Totalflow product line

# Technical bulletin 198

## TFIO Module Defect

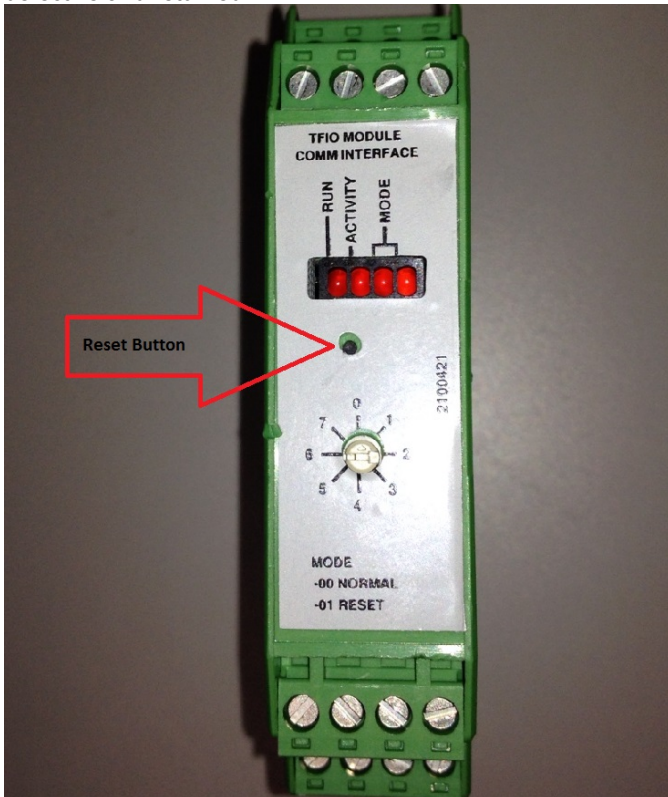
A number of TFIO modules have been found to have a manufacturing defect. The reset S1 switch may be mounted in such a manner that causes the button to be depressed. This condition will prevent proper functionality, and may fail to power up.

It is recommended to check your existing inventory for any defective modules. This can be done by depressing the reset button located on the front of the module, as shown below. If the button cannot be depressed, it should be deemed as defective and returned.
